**ADDENDUM NUMBER:** Addendum - Three  
**PROJECT TITLE:** Milwaukee County Parks Department

**RE-BIDDING of:**  
**VETERANS PARK SHELTER**  
**Site Number: 794**  
**Building Number: 1505**  
**750 North Lincoln Memorial Drive**  
**Milwaukee, Wisconsin 53202**

**PROJECT NUMBER:** P167-10422

**DATE OF ADDENDUM:** July 16, 2013

2 PARTIAL WASTE AND VENT ISOMETRIC  
P-100 NTS

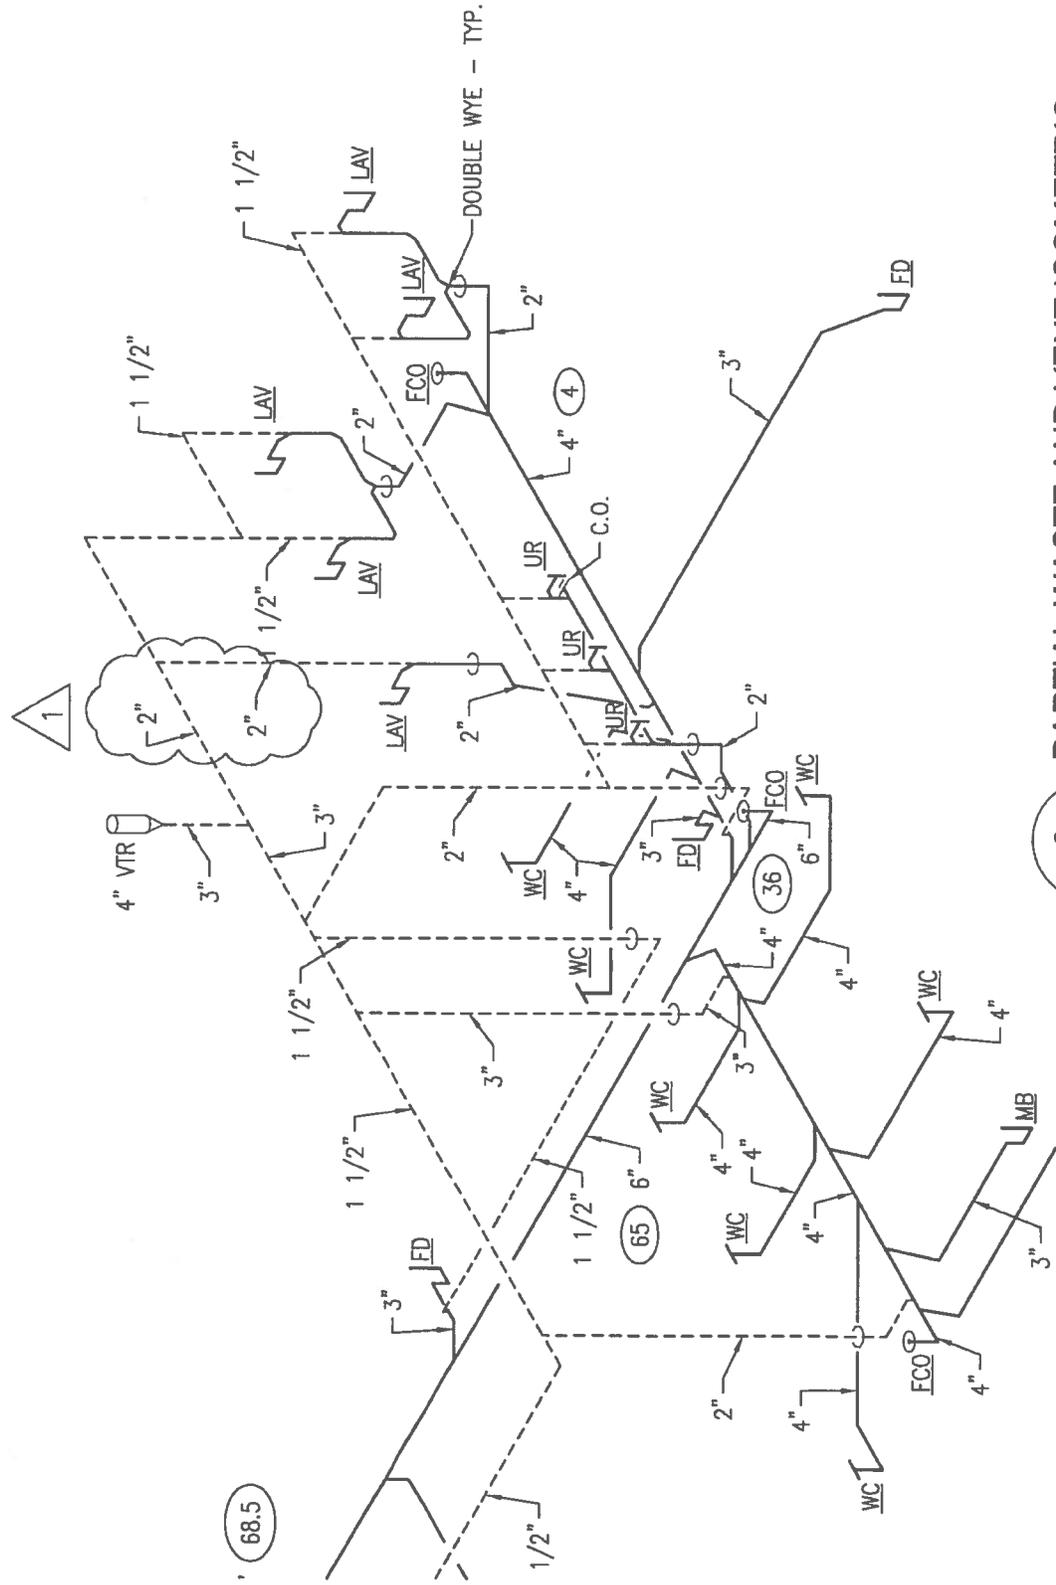
P-100 FOUNDATION PLUMBING PLAN AND WASTE PIPING ISOMETRIC:  
 Sanitary vent piping above ground has been revised; see attached revised WASTE PIPING ISOMETRIC,  
 Detail 2 / P-100.

REVISIONS  
1 VENT PIPE SIZE CHANGES.
